GEM Shanghai (China) will be the alternate assembly site for the IPak products

Date: Tuesday, April 19, 2016
PCR Reference: 770
PCN Reference: 770-PCN90-Public

N° 770-PCN90-Public

IR, JEDEC, GEM IPAK(TO-251) PACKAGE OUTLINE COMPARISON

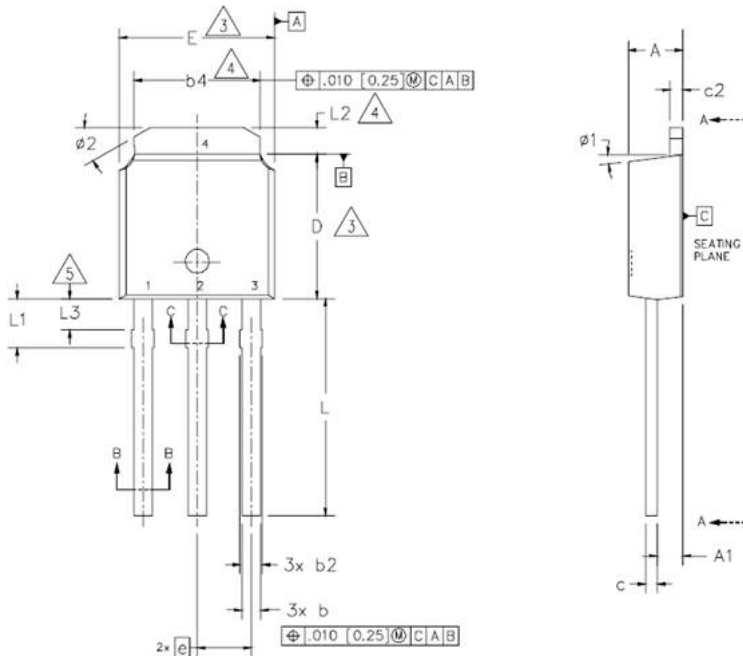
As the result of this change, the Bill of Materials and POD at the new assembly site will be as follows:

SYMBOL	SYMBOL DESCRIPTION	IR		JEDEC		GEM		REMARKS
		INCH		INCH		INCH		
		MIN	MAX	MIN	MAX	MIN	MAX	
A	Package thickness	086	094	086	094	087	094	GEM is JEDEC & IR Compliant
A1	Btm of leads to btm of pkg	035	045	350	050	035	045	GEM is JEDEC & IR Compliant
b	Leadwidth(with plating)	025	035	025	035	026	035	GEM is JEDEC & IR Compliant
b2	Standoff width(with plating)	030	045	030	045	030	045	GEM is JEDEC & IR Compliant
b4	Thermal pad width width	195	215	195	215	197	215	GEM is JEDEC & IR Compliant
c	Lead thickness(with plating)	018	024	018	024	018	024	GEM is JEDEC & IR Compliant
c1	Lead thickness(no plating)	016	022	016	022	016	022	GEM is JEDEC & IR Compliant
c2	Heatsink thickness	018	035	018	035	018	035	GEM is JEDEC & IR Compliant
D	Package height	235	245	235	245	236	244	GEM is JEDEC & IR Compliant
D1	Thermal pad length	205	-	205	-	205	-	GEM is JEDEC & IR Compliant
E	Package width	250	265	250	265	252	265	GEM is JEDEC & IR Compliant

E1	Thermal pad width	170	-	170	-	170	-	GEM is JEDEC & IR Compliant
e	Lead pitch	090 BSC		090 BSC		090 BSC		GEM is JEDEC & IR Compliant
L	Total lead length	350	380	350	380	354	370	GEM is JEDEC & IR Compliant
L1	Pkg to btm of lead stand off	045	090	075	090	075	090	GEM is JEDEC & IR Compliant
L2	Top of heat sink to mold pkg	035	050	035	050	039	050	GEM is JEDEC & IR Compliant
L3	Pkg to top of lead stand off	045	060	045	060	037	047	Minimum dim does not meet JEDEC & IR spec.

The package outline dimensions (POD) will be changed at the new assembly site (See description)
